**UNITED STATES  
NUCLEAR REGULATORY COMMISSION**

**SUBJECT: BRAIDWOOD STATION, UNITS 1 AND 2, NRC SPECIAL INSPECTION TEAM  
(SIT) REPORT 05000456/2010010; 05000457/2010010**

Report No: 05000456/2010010 and 05000457/2010010

Facility: Braidwood Station, Units 1 and 2

#### Unit 2 Auxiliary Feedwater Suction Vent Riser

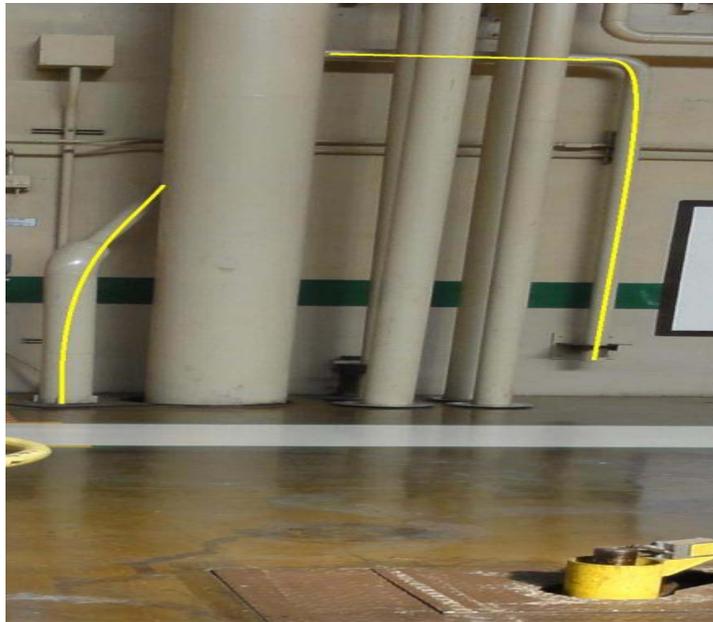
The AFW suction header includes two stand-pipes (or vent risers) used to attenuate AFW pumps suction pressure transients during pump startup by providing a source of water that is close to the pumps' suction and at a head equal to the water height in the condensate storage tank (CST). The CST is the preferred source of water to the AFW pumps. These transients occur because the motor-driven AFW pump accelerates at a higher rate than the water coming from the CST resulting in a temporary low suction pressure (assuming that the stand-pipes were isolated from the header). The high point on the stand-pipes is approximately 8.5 feet higher than the top of the CST. When the condenser hotwell high level setpoint is met, the hotwell overflow control valves open to transfer condensate reject to the CST via the condensate header using the CD/CB pumps. The condensate header communicates with the AFW suction header coming from the CST. When the flow rate of water rejected from the hotwell to the CST is greater than the discharge rate out of the AFW pumps, the level in the standpipe would increase and the conditions were great enough that water could spill onto the turbine deck, because the stand-pipes are open to the atmosphere on the common turbine building at the 451' elevation. The discharged water is able to flow through the floor and rain down the lower elevations through multiple openings in the floor. The team found that this occurrence was known to happen in multiple occasions in the past by the licensee without significant impact to the plant. However, on August 16, 2010, this occurrence caused the trip of Unit 1. As a result, one self-revealed finding of significance was identified, as discussed below.

Description: On August 25, 2010, the inspectors noted that the licensee failed to correct a condition that resulted in water to be discharged from Unit 2 to the common turbine building floor during reject of condensate from the Unit 2 condenser hotwell, which led to the reactor trip of Unit 1 on August 16, 2010.

The inspectors learned through interviews and discussions with plant personnel that water had been observed to discharge through the AFW stand-pipes on multiple occasions in the past. However, this occurrence was found to be captured in the CAP only on one occasion in 2009. In addition, the inspectors noted that the resolution of the issue captured in 2009 focused only on industrial safety and did not evaluate the impact of the water on plant equipment. This condition had not caused a reactor trip prior to the 2010 event.

Analysis: The inspectors determined that the failure to correct a condition that resulted in water to be discharged to the turbine building floor during reject of condensate from the condenser hotwell was contrary to Procedure LS-AA-125 and was a performance deficiency. This condition led to a reactor trip.
